DART AEROSPACE LTD		Work Order:	94348
Description: Crosstube Assembly (205/212 Low Aft)		Part Number:	D212-664-247
Inspection Dwg: D212-664-247 Rev: B		Page 1 of 2

DRAWING NO. D212-664-247	TITLE CROSSTUBE ASS'Y (205 LOW AFT)	REV. B	DART AEROSPACE LTD ENGINEERING ORDER		D.E.O. NO. D212-664-247-B-1	SHEET NO. SHEET 1 OF 1	SCALE NTS
DRAWN <i>q</i>	CHECKED <i>ASS</i>	MFG. APPR. <i>AS</i>	APPROVED <i>WD</i>		DE APPR. <i>WD</i>		
DATE 11.07.15	DATE 11.07.20	DATE 11.07.21	DATE 11/07/21		DATE 11.07.21

PURPOSE:

REPLACE MAGNOBOND WITH PROSEAL.

D212-664-247/-247B
ASSEMBLY DETAIL

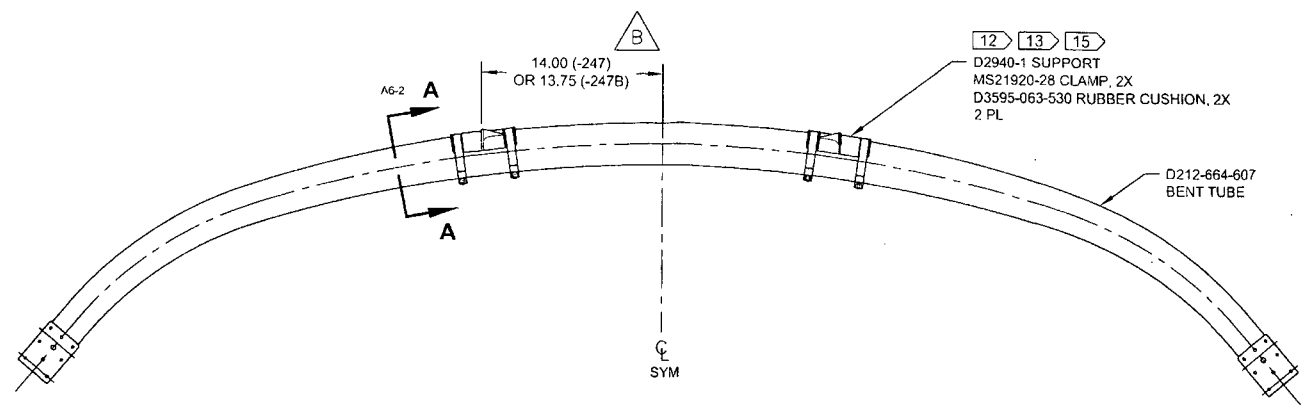
NOTE 12 & 15, SHEET 1 IS AMENDED AS FOLLOWS:

- 12) INSTALL D2940-1 SUPPORT USING 0.03" TO 0.06" THICK LAYER OF MAGNOBOND 6398 TO THE SURFACE OF D2940-1 THAT WILL BE IN CONTACT WITH THE CROSSTUBE PER QSI 015. LET CURE FOR 12 HOURS AFTER INSTALLATION AND PRIOR TO PACKAGING.
- 15) TORQUE CLAMPS 80 TO 100 IN-LB. ENSURE AT LEAST 1.5 THREADS SHOWING IN SAFETY AND THAT NUT HAS NOT BOTTOMED-OUT AFTER TORQUING.

- 12) TO INSTALL D2940-1 SUPPORT: ABRASE MATING SURFACE OF SUPPORT AND CROSSTUBE WITH 180-GRIT SANDPAPER AND REMOVE RESIDUE WITH MEK (OR EQUIVALENT). APPLY A 0.04" TO 0.07" THICK LAYER OF PROSEAL 890 CLASS B-2 (OR AMS-S-8802 CLASS B-2) SEALANT TO MATING SURFACE OF SUPPORT.
- 15) TORQUE CLAMPS 80 TO 100 IN-LB. ENSURE AT LEAST 1.5 THREADS SHOWING IN SAFETY AND THAT NUT HAS NOT BOTTOMED-OUT AFTER TORQUING. **PRIOR TO PACKAGING, RE-CHECK TORQUE ON CLAMPS AFTER PROSEAL 890 SEALANT HAS CURED FOR 72 HOURS.**
